U.S. Department
of Transportation
**Federal Highway
Administration**

December 1, 1997

On November 21, 1997, you and members of your company met with Messrs. James Hatton and Richard Powers of my staff. You delivered a letter addressed to me, dated November 19, which requested the FHWA to accept the QuadGuard - Low Maintenance Cartridge (LMC) System as a National Cooperative Highway Research Program (NCHRP) Report 350 test level 3 (TL-3) crash cushion. You also provided us copies of a report entitled "QuadGuard - LMC System Qualification to NCHRP 350 Engineering Summary" dated November 1997, which included the E-Tech report, "NCHRP Report 350 Crash Test Results for the QuadGuard - LMC System," and a videotape of the tests that were conducted. The QuadGuard - LMC is a reusable, partially self-restoring crash cushion that utilizes the main components of the NCHRP Report 350 - qualified QuadGuard, except for the energy dissipation cartridges, which have been replaced with elastomeric cylinders of the type used in your NCHRP Report 230-qualified Low Maintenance Attenuator (LMA).

In your March 12 letter to Mr. Henry Rentz, you requested formal acceptance of your QuadGuard 69/90 Low Ma

FIG. 2

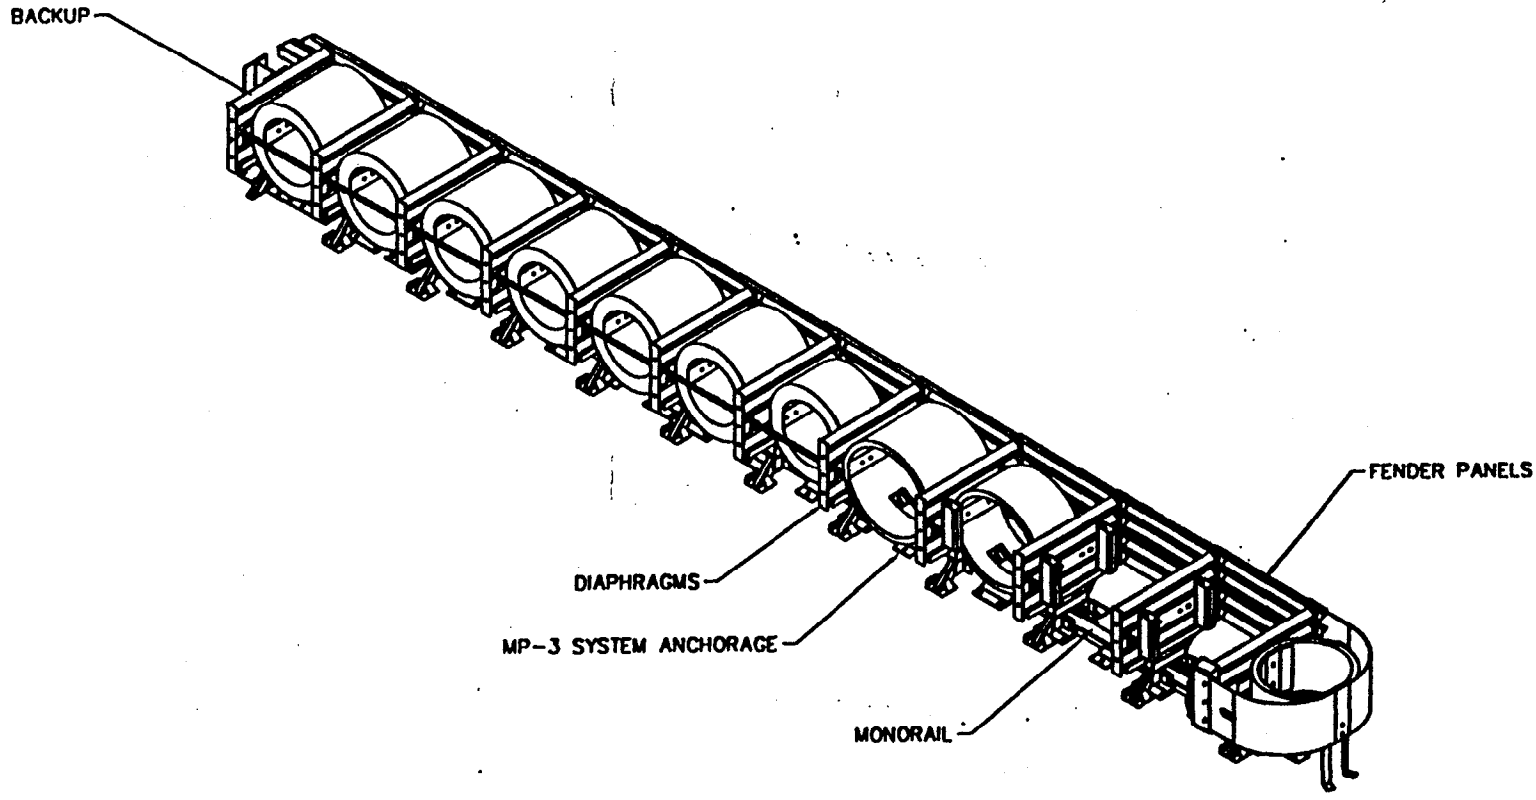
The QuadGuard - LMC unit tested was an 11 bay unit, 10 163 mm long and 1220 mm wide. It consisted of a monorail assembly anchored to a concrete pad, steel diaphragms, steel fender panels, a nose assembly, and a steel strut backup. The rear-most nine bays contained energy absorbing elastomeric cylinders as shown in the cutaway view in Enclosure 1. This drawing also identifies the system elements that are identical to those used in the previously-accepted QuadGuard unit.
